SERVICE BULLETIN

N° 139-462

ATA 25 - INSTALLATION OF ACTIVE NOISE REDUCTION HEADSET

This Service Bulletin is issued in order to provide the necessary instruction on how to perform the installation of kit active noise reduction headset P/N 4G2350F00113.

Figure 7

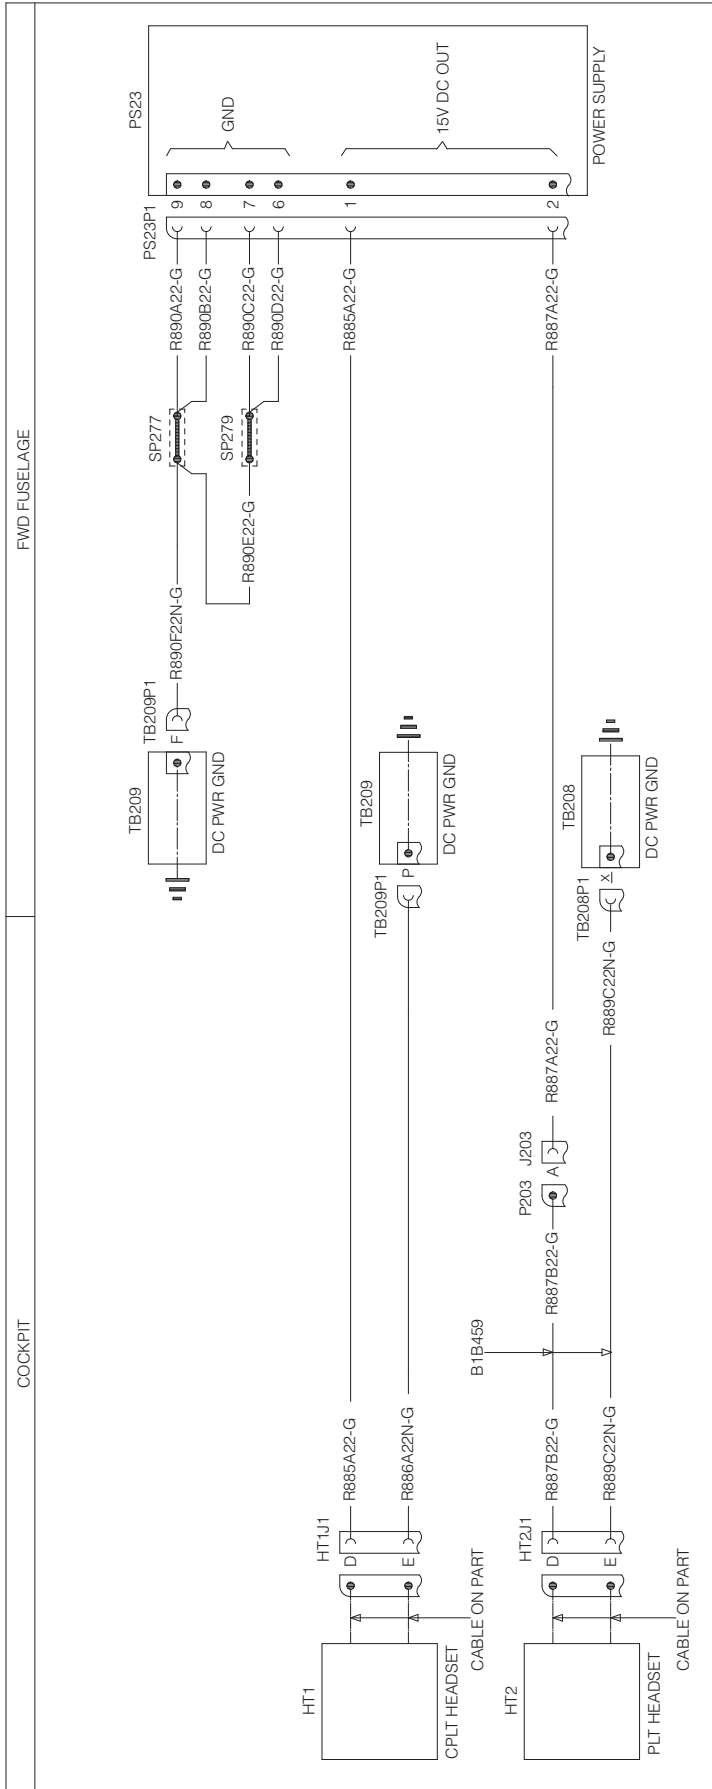
3.6 With reference to Figures 3, 4, 5 and Figure 7 wiring diagram, perform the electrical connection of the cable assy P/N 3G9B01A30301 (B1A303) between co-pilot headset connector HT1J1, DC POWER GND terminal board TB209P1, sectioning connector J203 and power supply connector PS23P1. If necessary use the following electrical contacts:

3.7 With reference to Figures 3, 4 and 7 wiring diagram, perform the electrical connection of the cable assy P/N 3G9B01B45901 (B1B459) between pilot headset connector HT2J1, sectioning connector P203 and DC PWR GND terminal board TB208P1. If necessary, use the following electrical contacts:
